Addendum 03

Date: 05-22-2026
Project: 22011 – Spin Lofts
521 21st Ave
Council Bluffs, IA

ELECTRICAL DRAWINGS

FLOOR PLANS - LEVELS 01 & 02 - ELECTRICAL

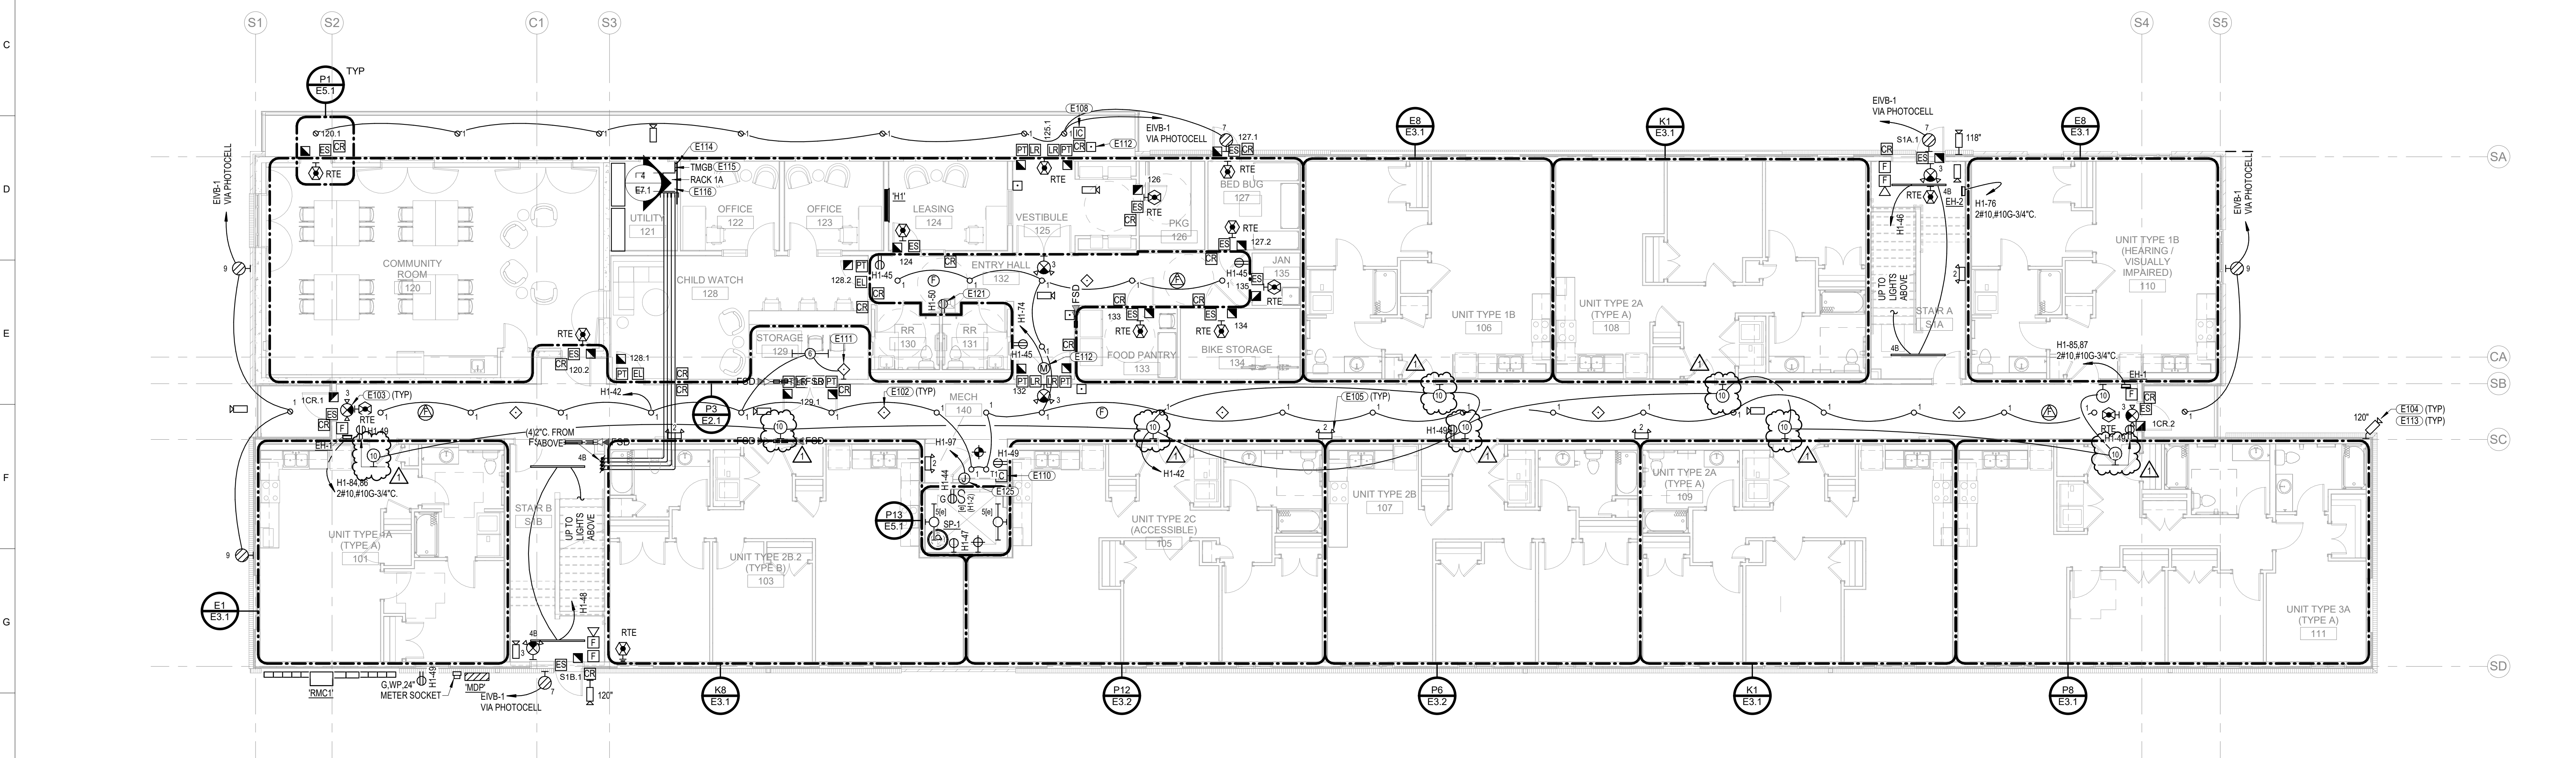
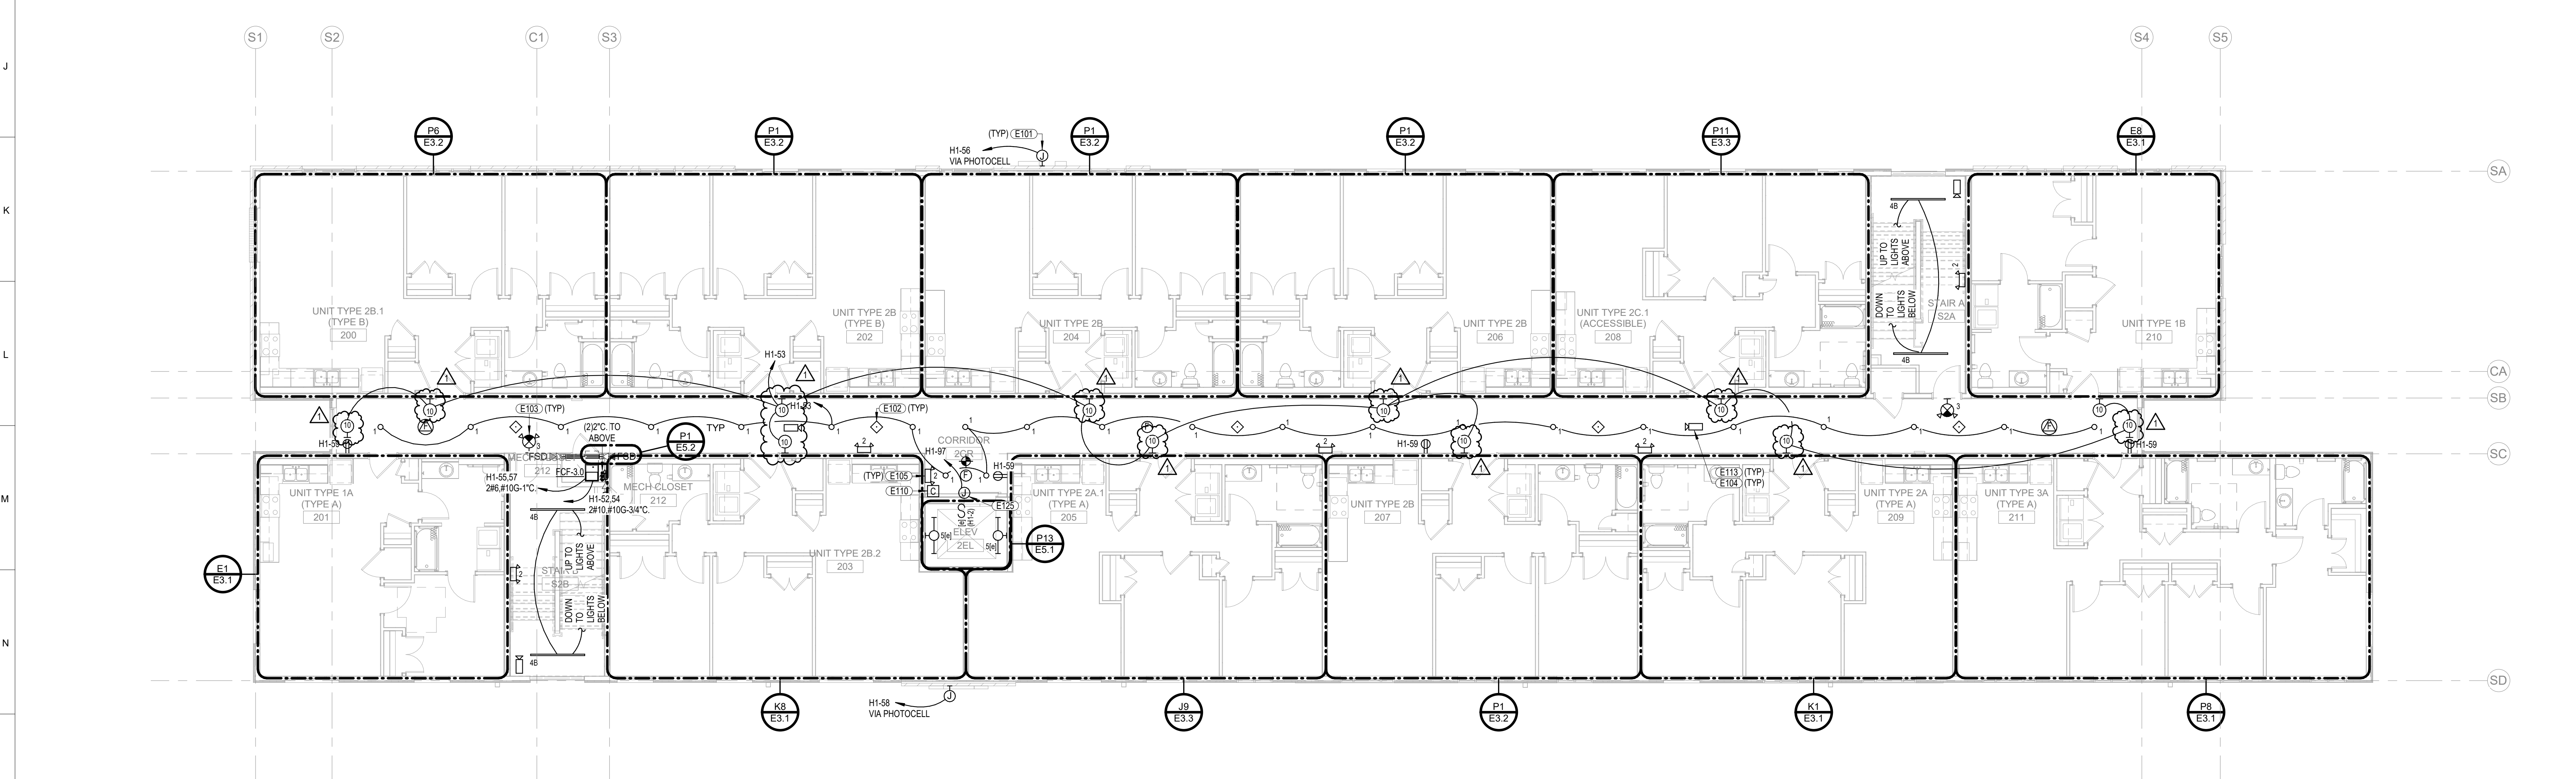
1. Sheet E1.1: FLOOR PLANS – LEVELS 01 & 02 - ELECTRICAL
 - a. Revised location of unit entry light fixtures.
2. Sheet E1.2: FLOOR PLANS – LEVELS 03 & 04 - ELECTRICAL

FLOOR PLANS - LEVELS 03 & 04 - ELECTRICAL

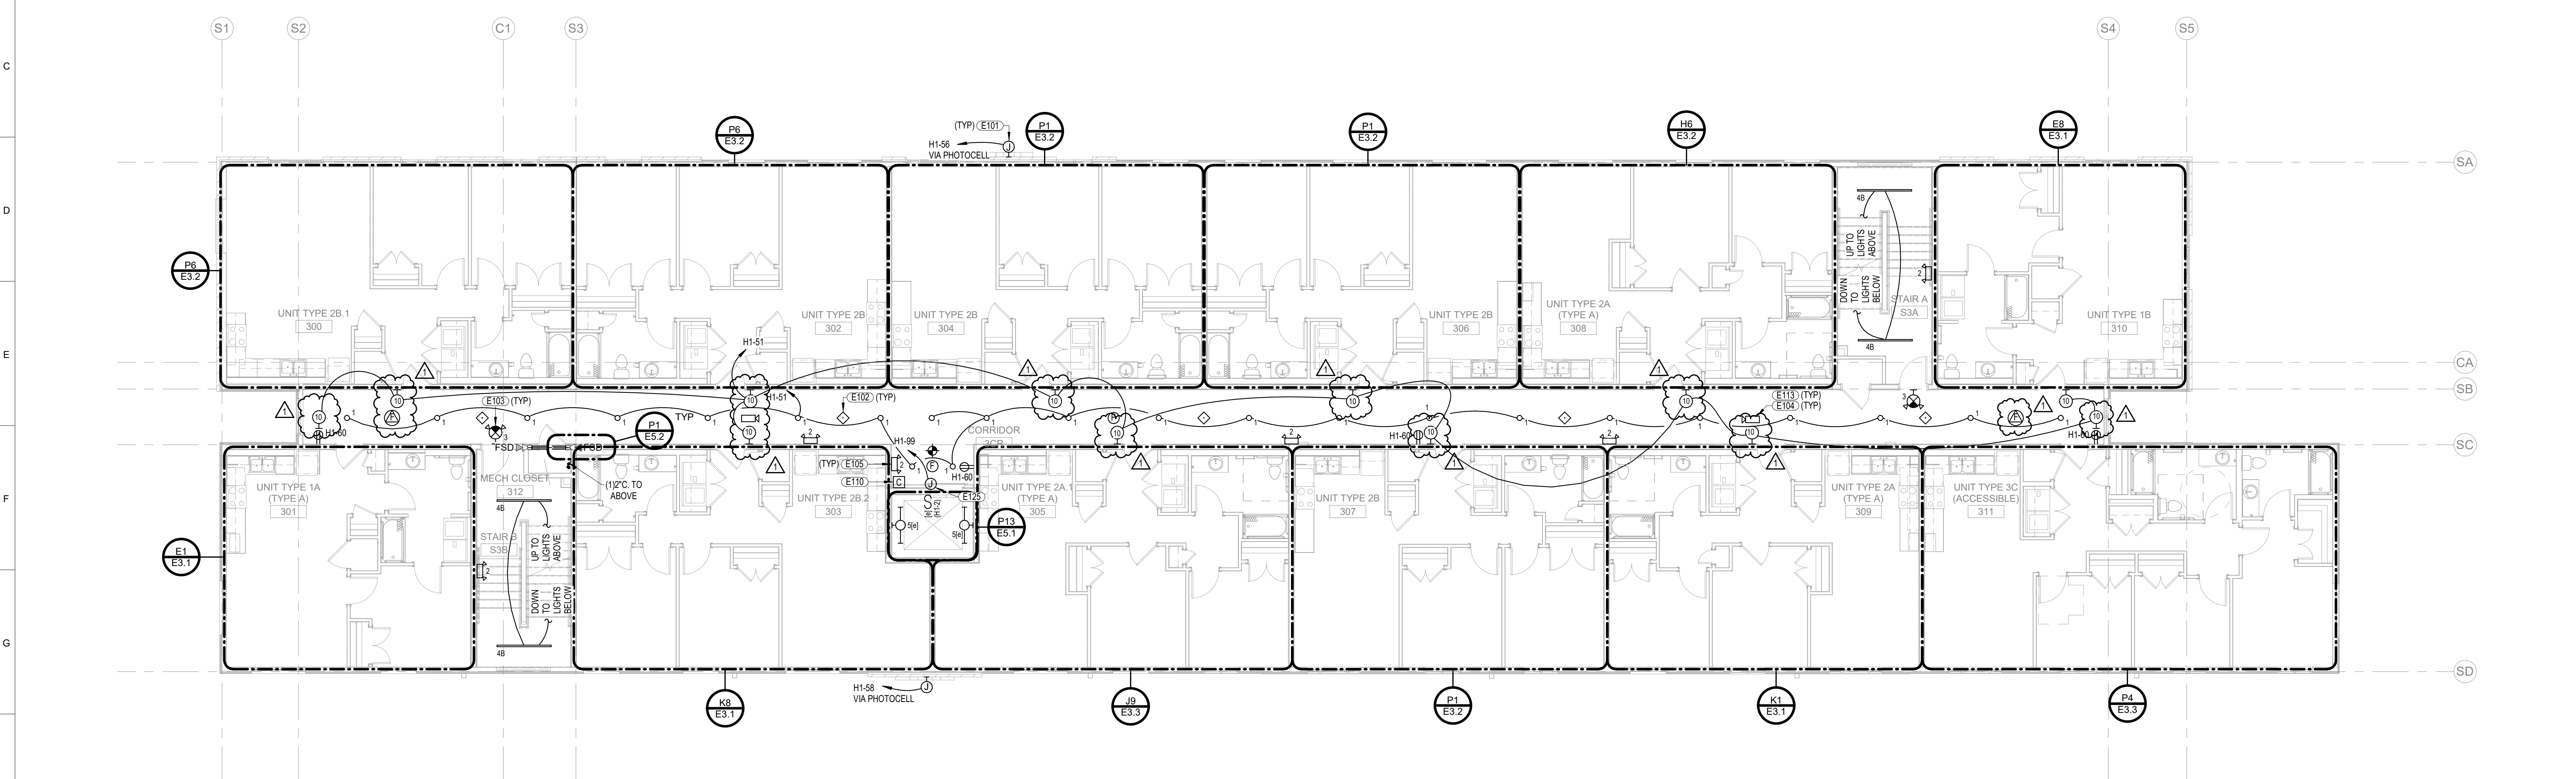
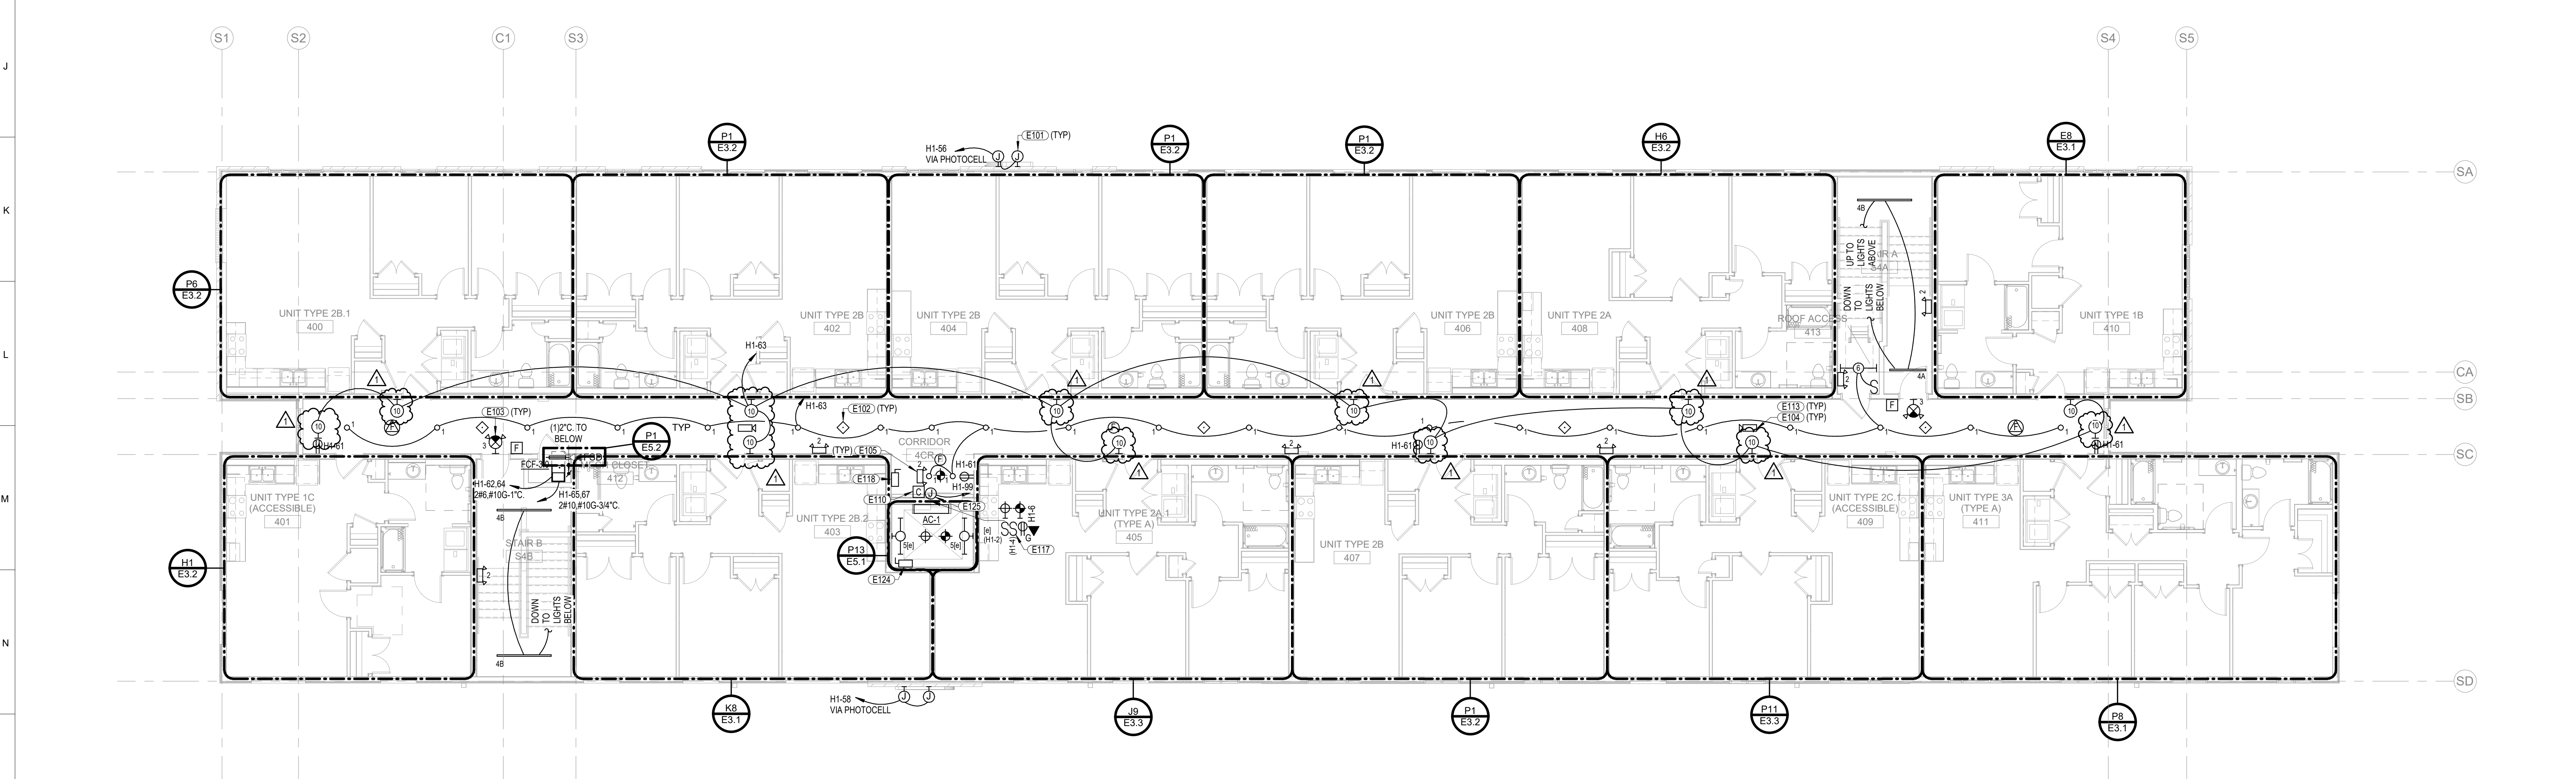
- a. Revised location of unit entry light fixtures.
 - b. Revise E14, trash enclosure plan to include gates at trash enclosure.
3. Sheet E3.1: ENLARGED UNITS PLANS - ELECTRICAL

E1 TYPICAL UNIT PLAN - 1A - BED TYPE A - ELECTRICAL

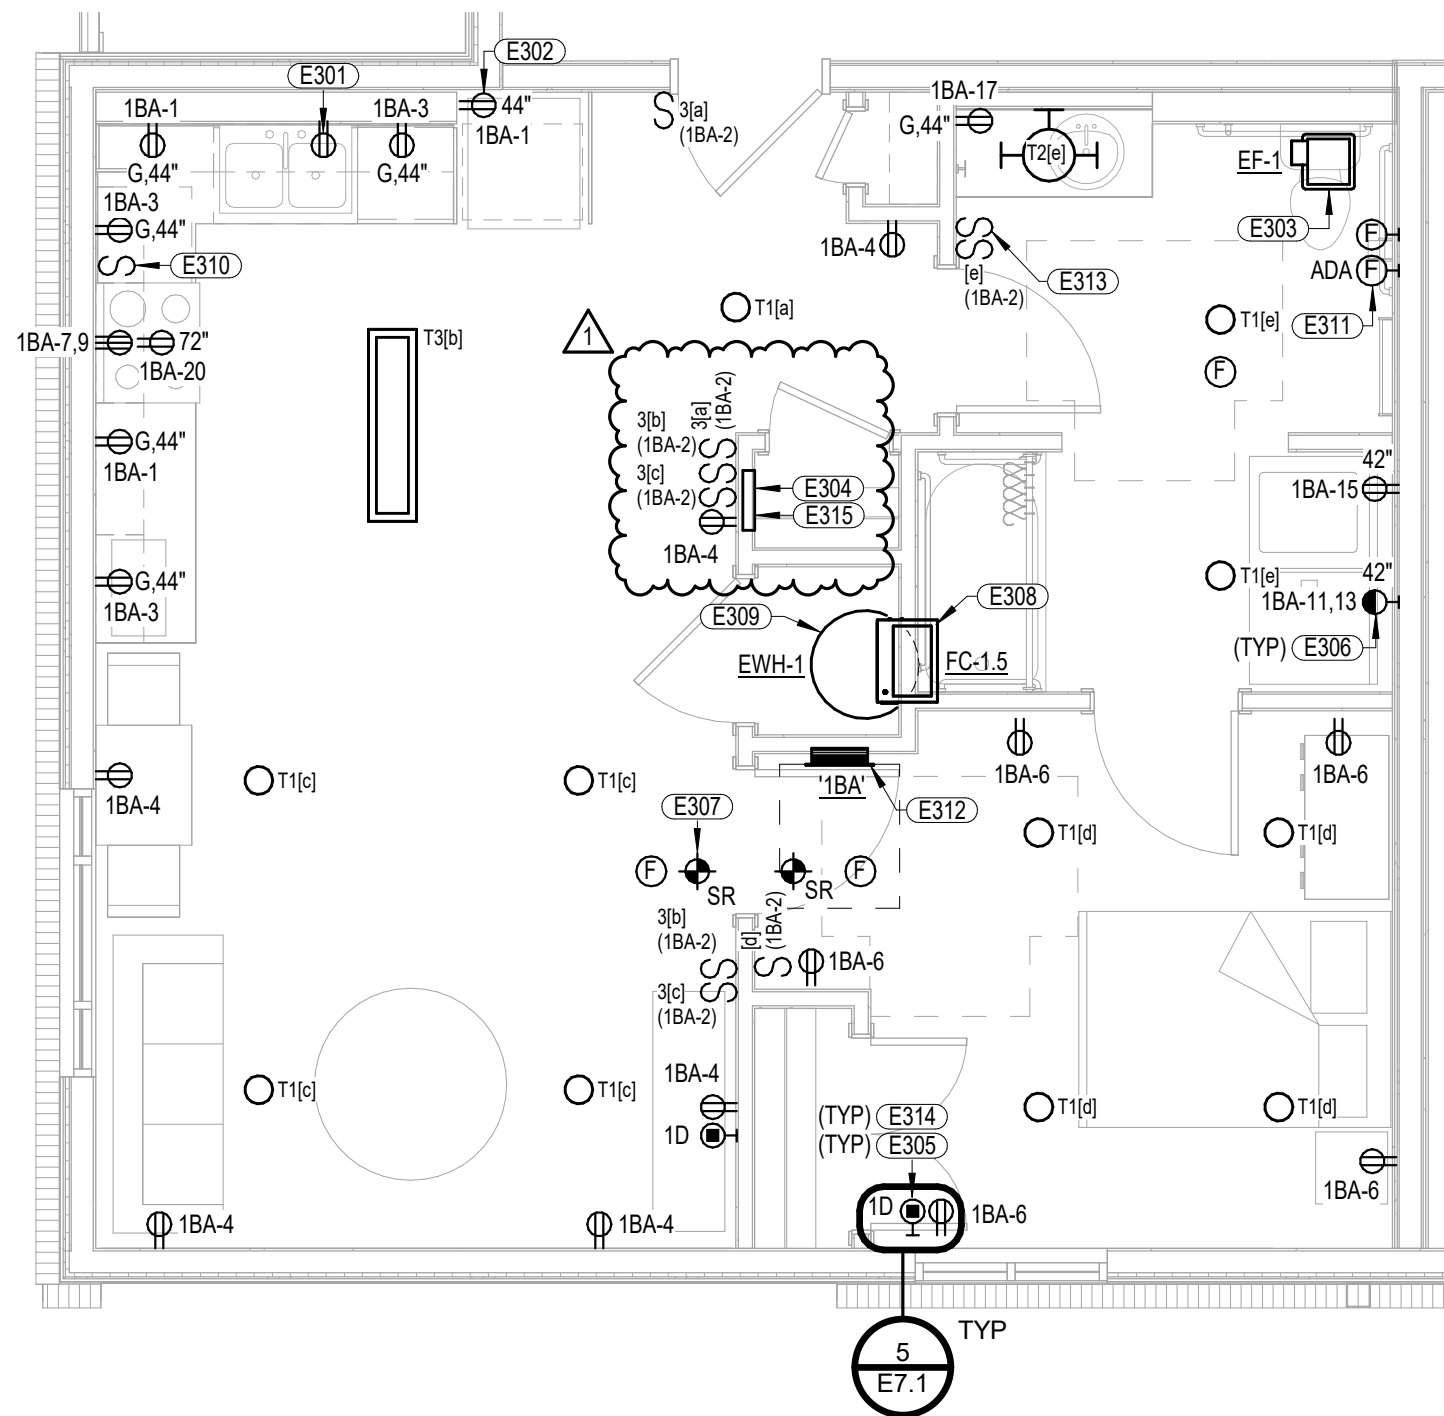
- a. At Unit Plan 1A, revise SOHO box location.
 - b. At Unit Plan 1B, revise SOHO box location and electrical outlet and switch by unit entry door.
 - c. At Unit Plan 2A, revise SOHO box location.
